CERTIFICATE OF APPROPRIATENESS

Property: 504 Avondale St, lot 2, tract 3A, block 6, Montrose Subdivision. The property includes a historic 3,124 square foot two-story residence situated and detached garage on a 7,800 square foot (60' x 130') interior lot.

Proposal: Alteration – Replace all wood 1-over-1 windows with wood 1-over-1 windows to fit within existing openings. An application to replace all wood 1-over-1 windows with vinyl 1-over-1 windows was denied at the October 23, 2014 HAHC meeting.

Description of Damages by Applicant

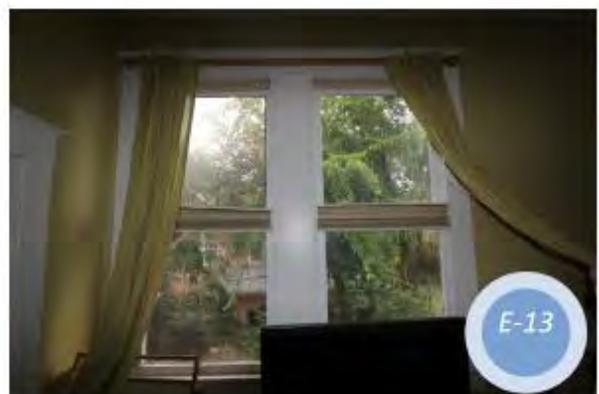
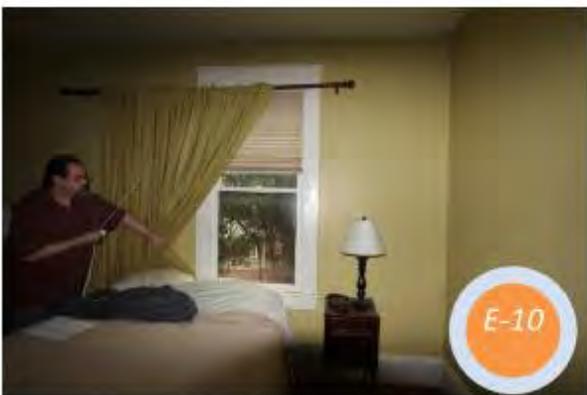
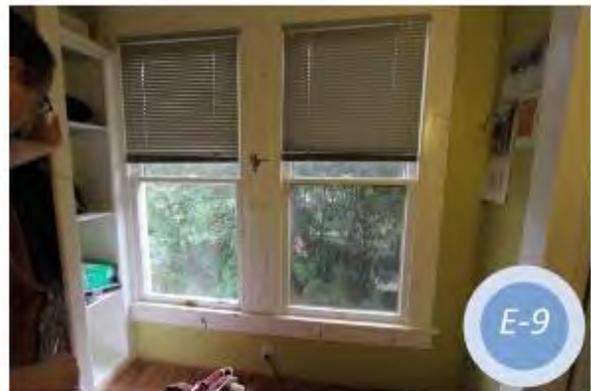
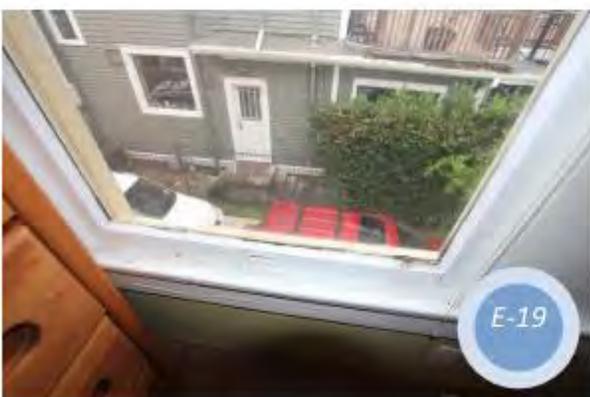
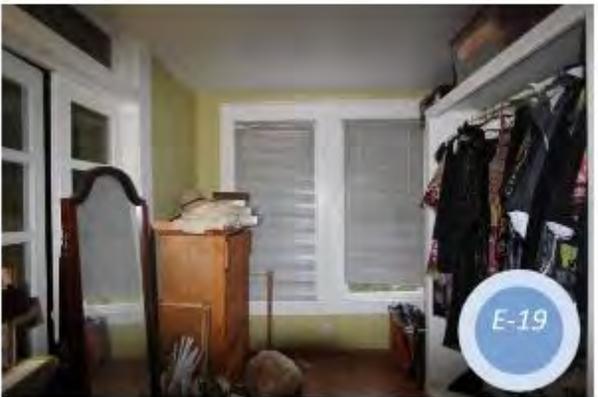
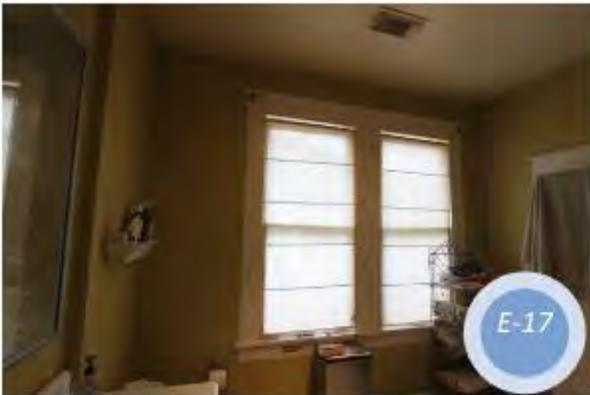
Broken window frame E-1, E-3, E-5, E-8, E-10, E-13, E-15, E-18, E-19

Rotten window frame E-7, E-9, E-14, E-16, E-17

Damaged window sill E-9, E-13, E-14, E-17, E-18, E-19

STAFF PHOTOS

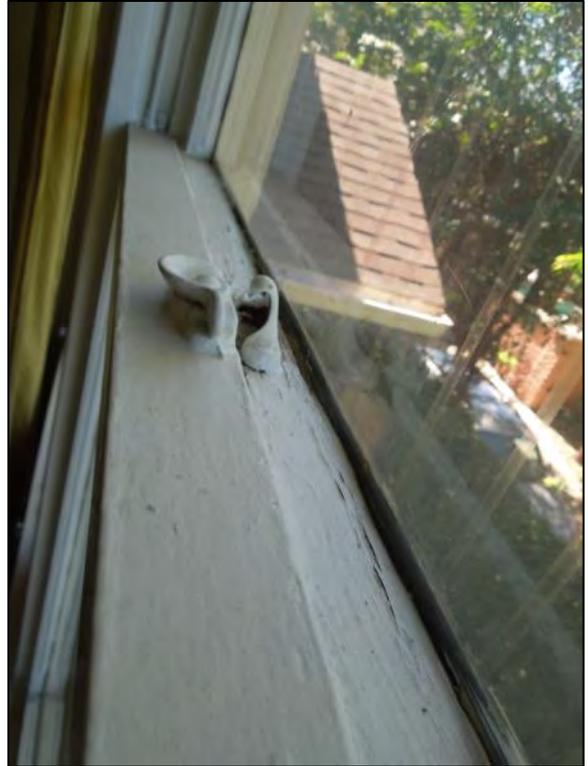
<i>The original wood windows are a distinguishing feature of the property and should be retained. Staff confirmed some damage of the original windows but believe they are not beyond reasonable repair.</i> | |

WINDOWS – PAINTED SHUT, SOME ROT, LOOSE GLASS
